AGENDA

The Columbia Architectural Design Review Team will meet on Tuesday, February 7, 2023 at 9:00 AM in Conference Room A on the basement level of City Hall, 700 N. Garden Street. The Planning Commission will consider the following:

PROJECT DESCRIPTION:

The applicant is requesting an amendment to the Honey Farms Master Planned Unit Development for the construction of 205 townhome units. As a revision to this previously approved PUD, all standards of Zoning Ordinance 4000 shall be applicable that include architectural design elements as cited in Article 4, Development Standards for a PUD-R.

HONEY FARMS:
SCHEMATIC ELEVATIONS

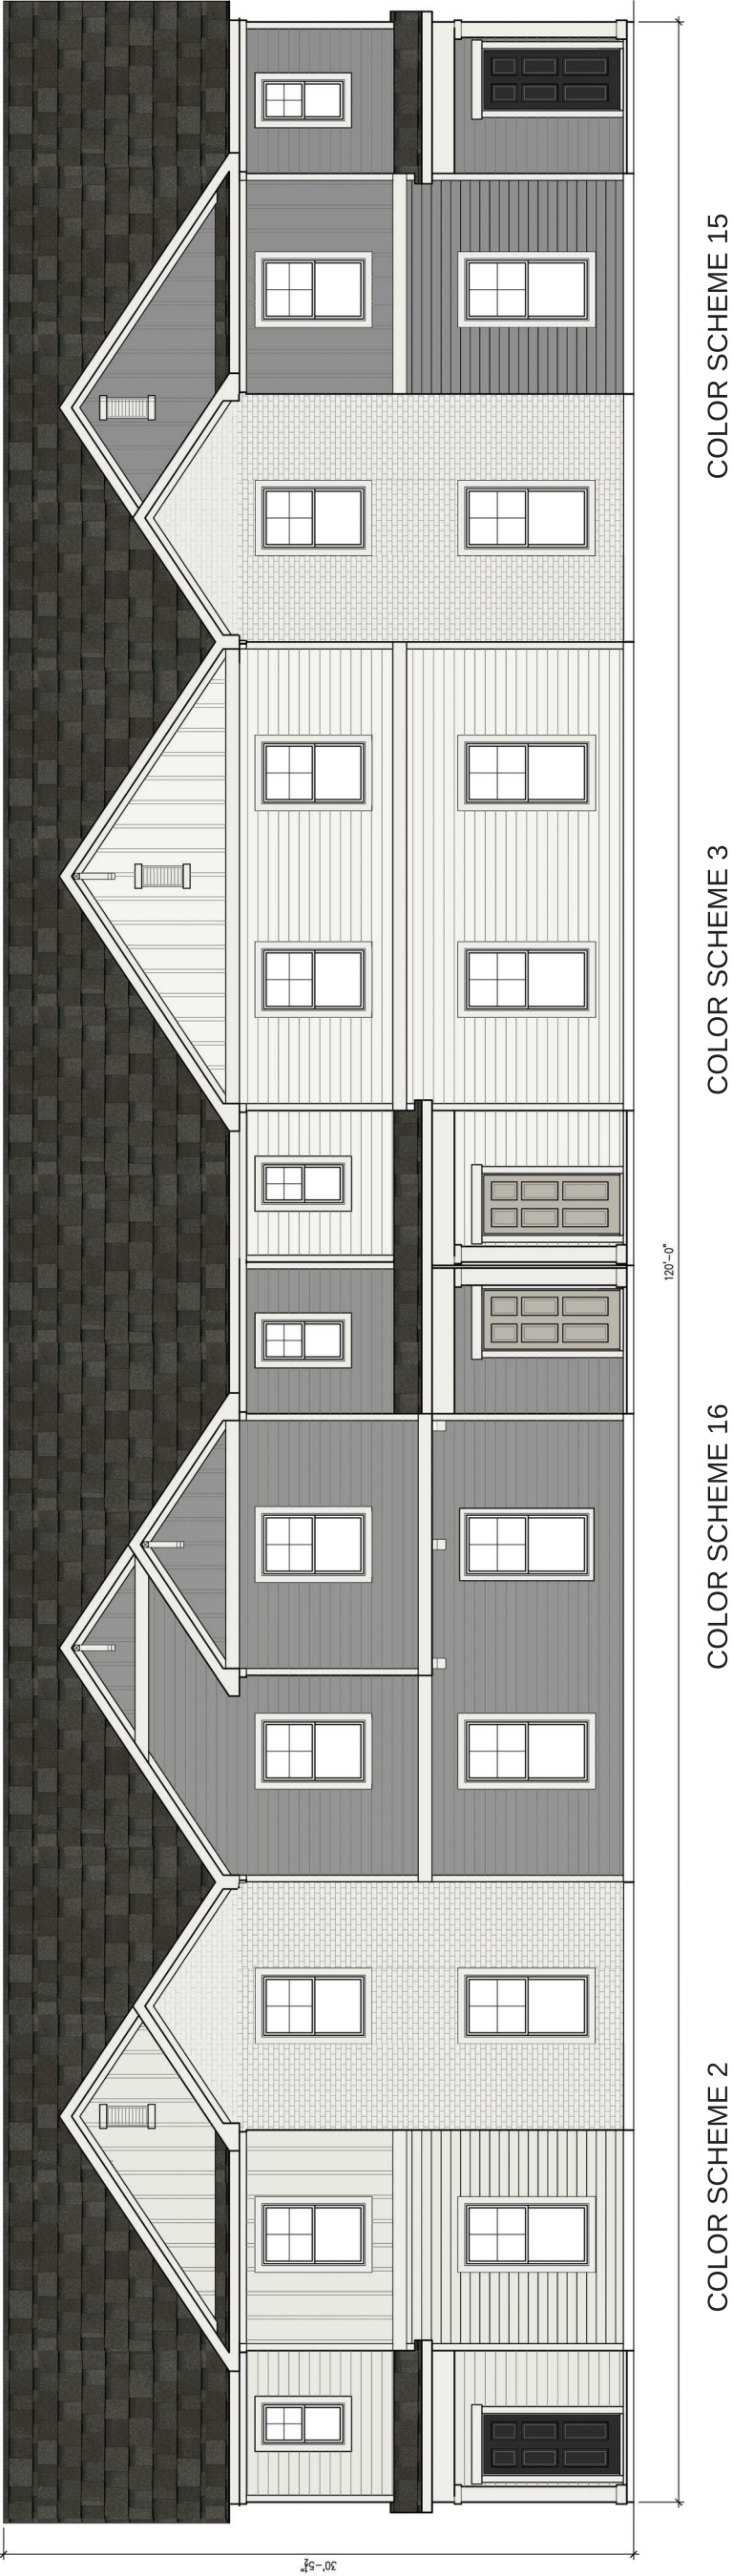
- Primary building materials on façade consist of cementitious siding and brick that are permitted materials on primary building facades.
- Façade articulation is required for a façade greater than 100'. The applicant has selected to achieve this articulation with the use of multiple colors with a material change of a combination of fiber cement board and white brick.

- All elevations require a foundation cladding of brick or natural stone. Multiple elevations do not indicate this foundation cladding requirement. This would achieve the building composition requirement of having a defined base, middle, and cap.

- Garage design is required to contain carriage house style doors with a garage door width of 9ft and each garage door having ornamental lighting above it. Garage design does not indicate ornamental lighting fixtures with carriage house style doors with door widths than may exceed 9ft.

- Window trim details required for top plate if fiber cement board surrounds window; or soldier course above lintel and rowlock course below sill for brick elevations. These requirements are not detailed in submitted elevations.

- Details are required showing that gable and rakes overhang at least six inches.
- Details are required showing that window sill height is 5' min above grade at façade

- Indicate details that's show minimum 6' clear depth for porch frontages.
- Façade variety is indicated as being broken up by color, noting that no more than one façade shall be on the same block face or within view of the same façade.

- Details shall be given regarding porch pier cladding indicating brick or natural stone.
- Details shall be given regarding architectural design of pool house in amenity area.
